SB Number:	SB 2H0-004	Creation Date: 17/04/2008
Subject:	Ensure proper detection of interlock SW in left cover 1	
Model:	KM-2560/3060/2540/3040

Arm left Interlock SW (No.1)

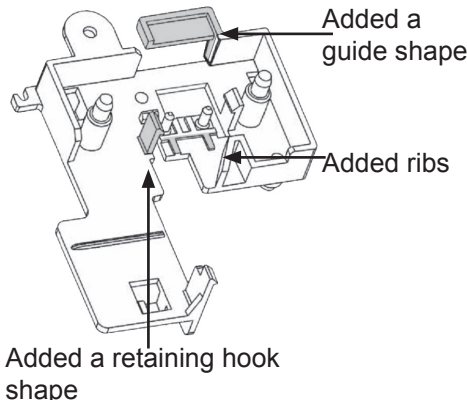
Contents of changes	1. The dimensions of the Arm left interlock SW (No.1) have been changed to ensure proper detection of the interlock SW. 2. The shape of Mount left interlock SW (No.2) has been changed. 3. The 2 Sponges (No.3) have been removed, because they touch the changed Mount left interlock SW (No.2)
----------------------------	---

A: Old size=9mm
New size=16,2mm

B: Old size=4mm
New size=4,6mm

Mount Left Interlock SW (No.2)

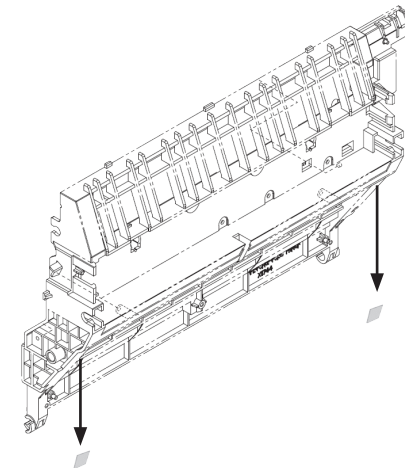
Removed Sponges (No.3)

Field measure	When installing Mount left interlock SW (No.2) in an older model, remove sponge (No.3)
----------------------	--
